TOWN OF SULLIVAN'S ISLAND DESIGN REVIEW BOARD

REGULAR MEETING MINUTES Wednesday, August 19, 2020

1857 I'On Avenue: Heather Wilson, applicant, requested conceptual approval to construct two accessory structures on a property designated as a Sullivan's Island Landmark. No modifications to the Zoning Standards were requests. (TMS# 529-07-00-072)

FIRST FLOOR PLAN
 scale 1/8" = 1'-0"

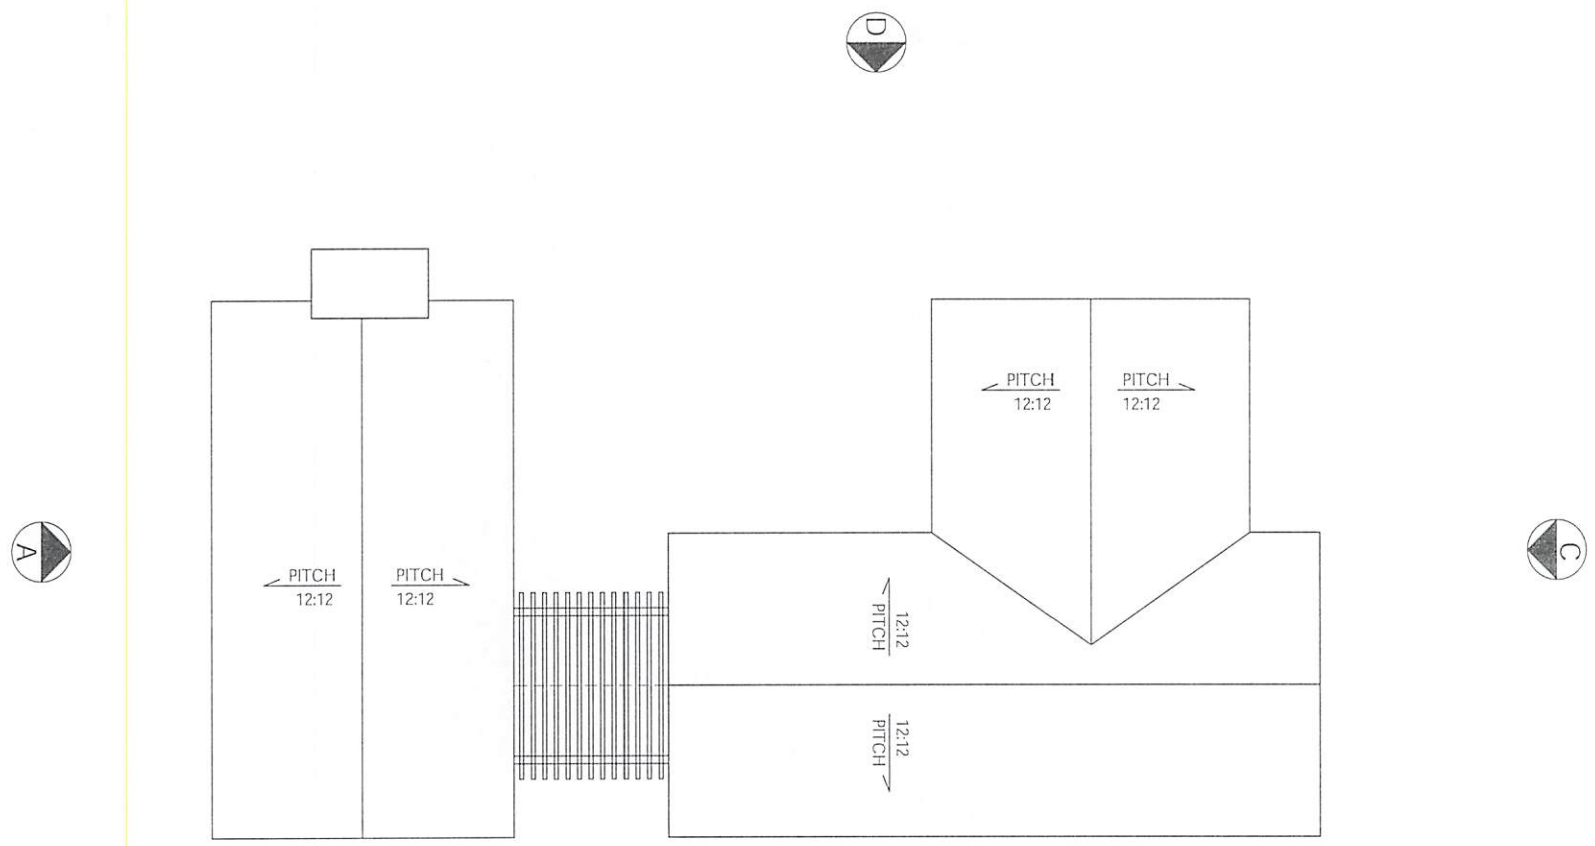
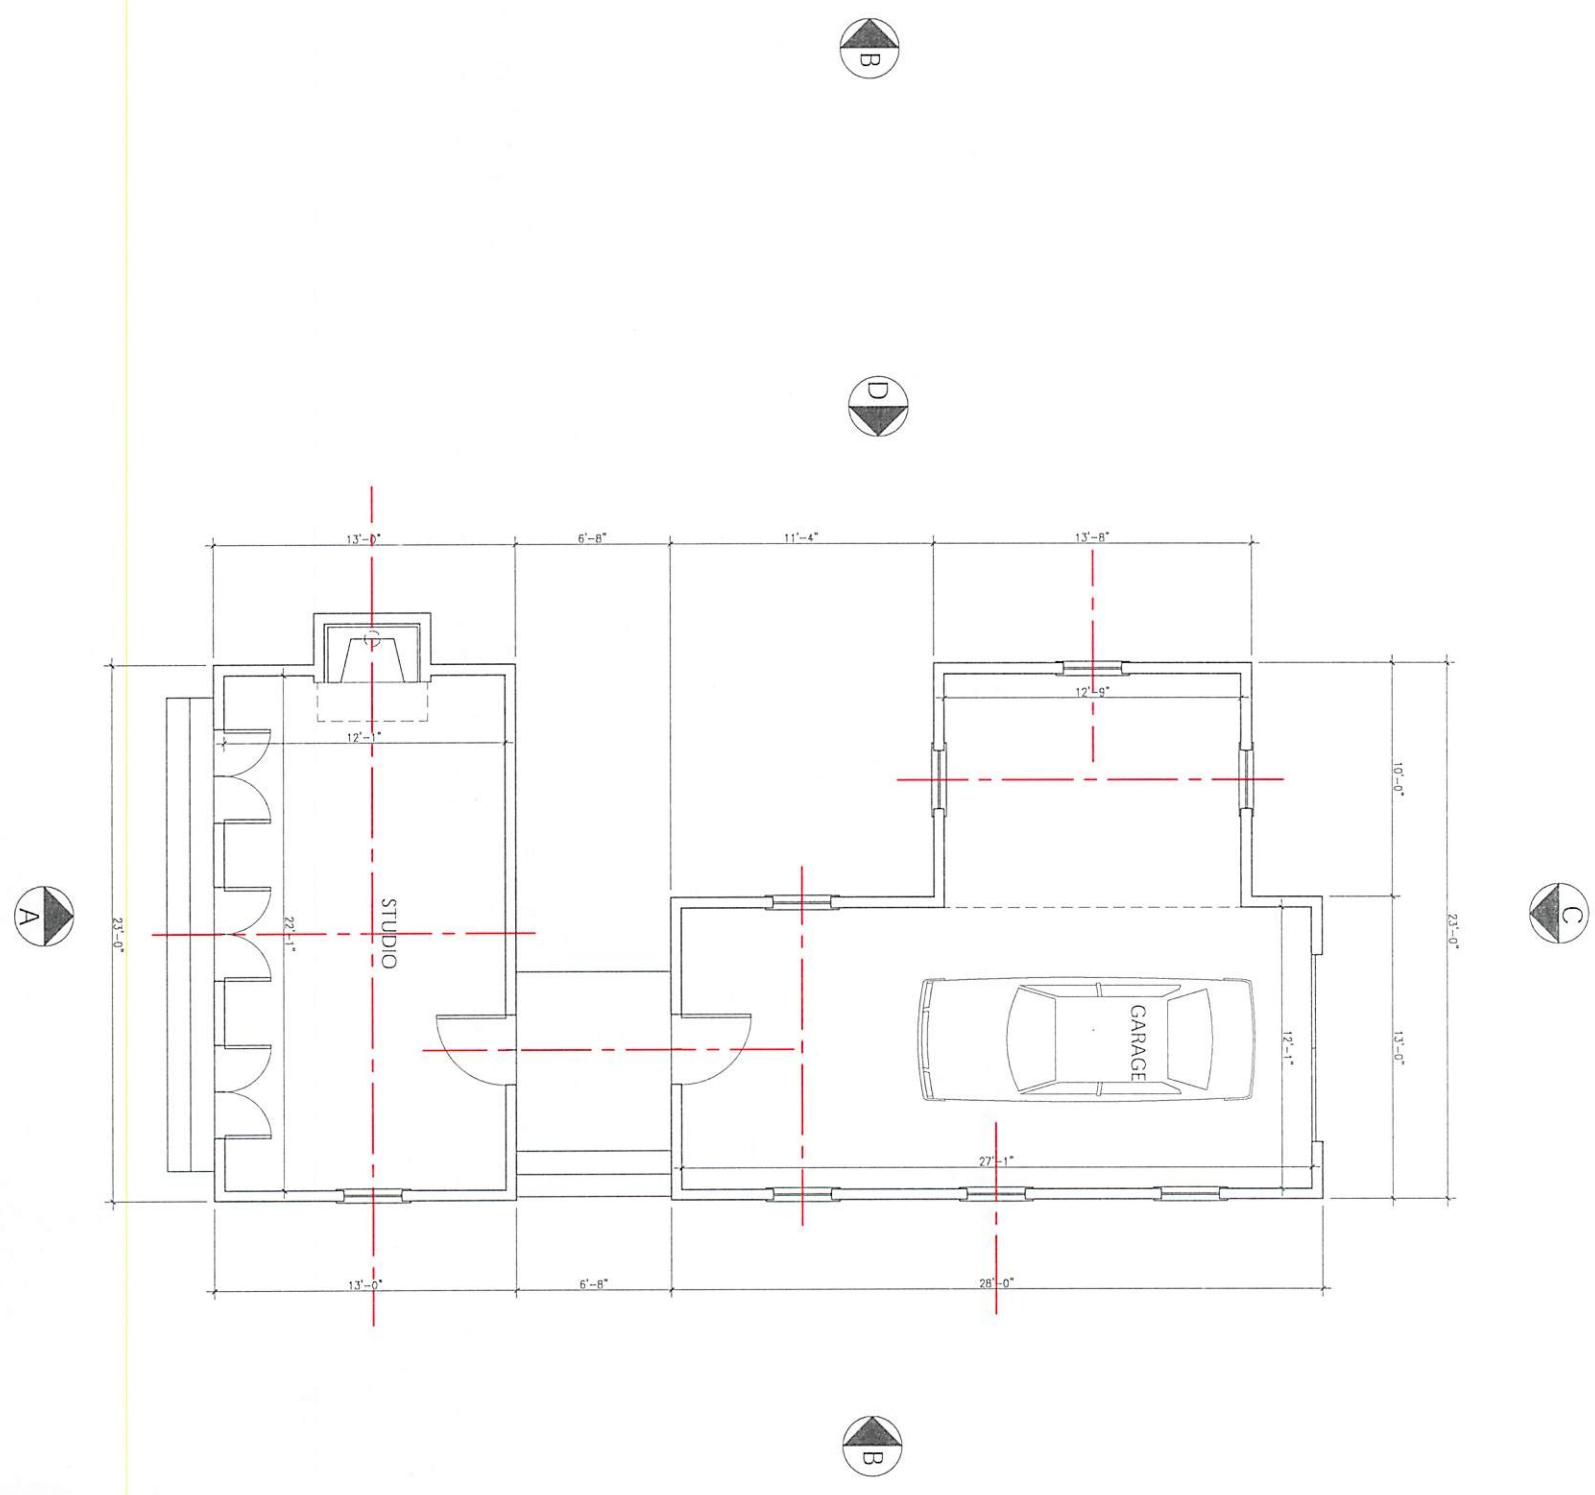
The applicant requested that the Design Review Board grant approval for an accessory structure that is 900 square feet in principal building square footage. Mr. Henderson stated this overturning staff's current interpretation would allow very large structures across the island at 900' SF and 21.5' in height which would open the door to very large structures. Mr. Henderson stated that when there is a challenge of staff interpretation related to discretionary DRB increases, the Design Review Board becomes the reviewing authority.

Ms. Wilson stated that the height of the structure will be at 18 feet. It will not exceed the zoning standards. The applicants would like the shed roof on the garage which gives them a two-car garage.

Mr. Wichmann asked about the ridge height to the accessory structures and the main structure. Ms. Wilson stated the structure itself at its highest ridge is 25 feet and 4 inches and the accessory structures are 18 feet. Mr. Wichmann asked if there was anyway to make it look smaller. Ms. Wilson stated that if gets any smaller it doesn't look right and any narrower you won't be able to fit two cars in the garage.

Mr. Craver restated his motion by approving the application with the 900 square foot maximum for both structures which includes a lean-to component. Mr. Lewis seconded this motion. All were in favor. None opposed. Motion passed unanimously.

FIRST FLOOR PLAN DEMO
 scale 3/32"=1'-0"
 [Red dashed line symbol] DEMO

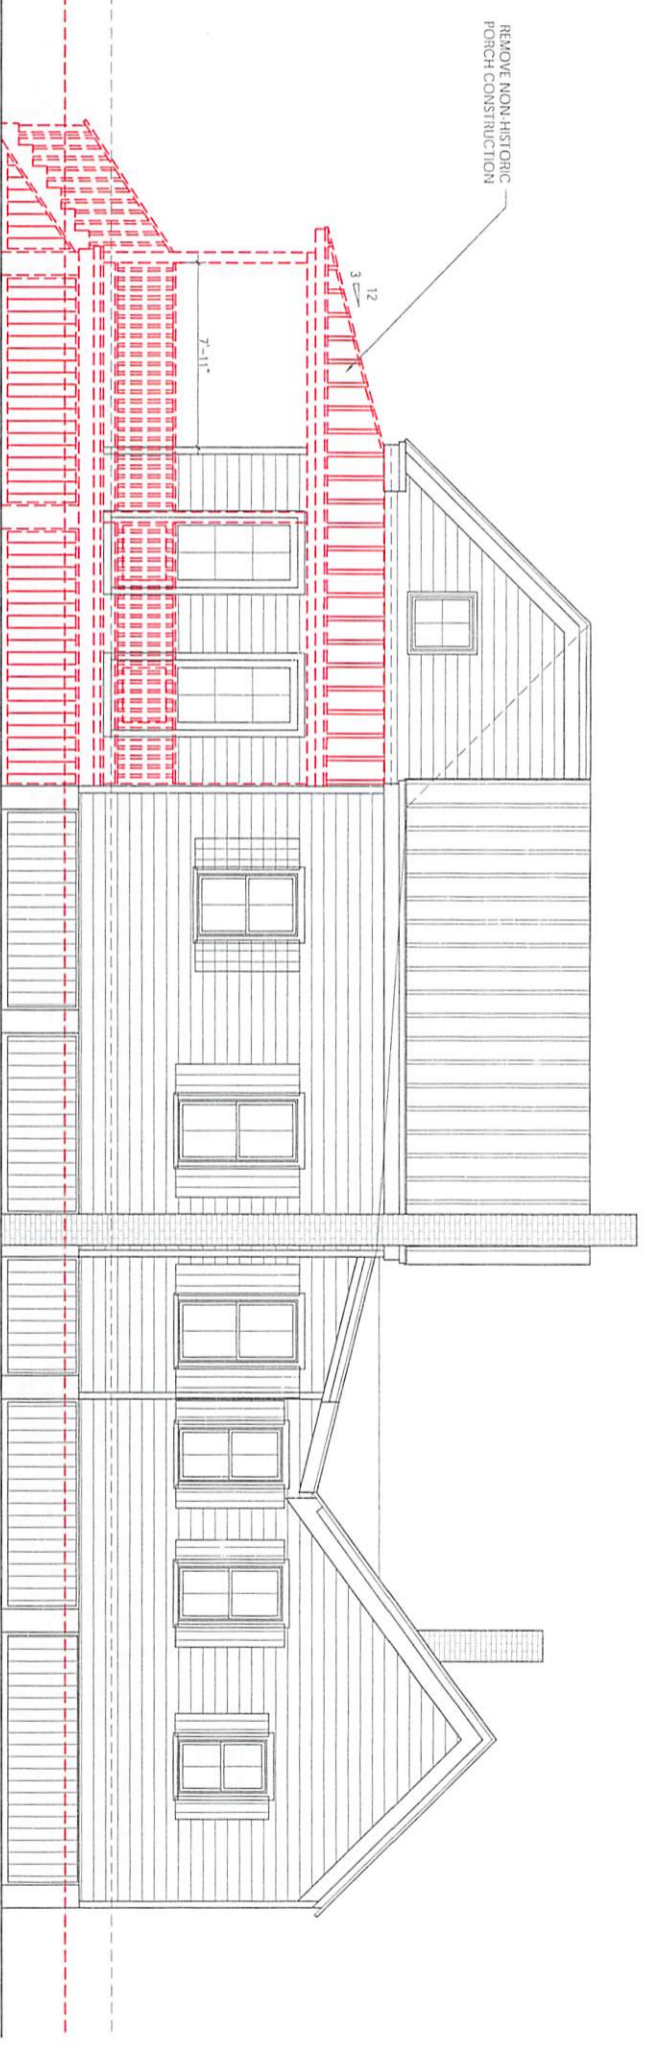
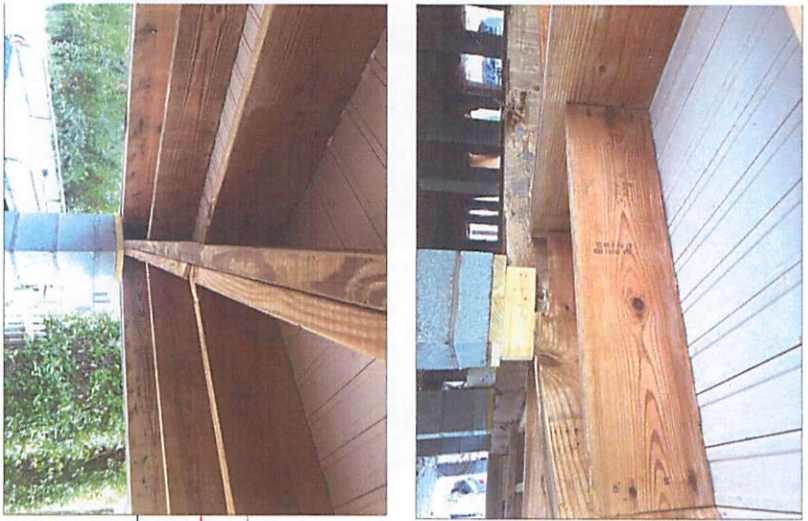
the home. Mr. Henderson stated that staff recommends granting the approval for the swimming pool and accessory structure at 750' square feet but believes that the porch extension is not compliant with the historic preservation standards because the extension of the front porch by 2' would destroy the façade porch's original scale and proportion of the home. This spatial relationship should be maintained.

Mr. Wichmann asked if the front porch of the home would go from 8 feet to 10 feet in depth. Ms. Wilson stated that the porch is currently less than eight feet right now. Mr. Wichmann struggled with granting the approval of the porch considering that the job of the Board is to protect the historic nature of these homes on Sullivan's Island. Ms. Wilson stated that the porch is not historic. The porch is the nature of the historic porch but the actual materials are no longer historic.

Mr. Coish stated that the application presented looks good. He said he believes it looks better with the 900 square feet but is nervous about setting a precedent for the future. Mr. Coish is concerned about the 2-foot extension on the porch.

Mr. Craver made a motion to approve the original application submitted granting the 900 square feet maximum for the accessory structures and the porch extension. Mr. Lewis seconded this motion.
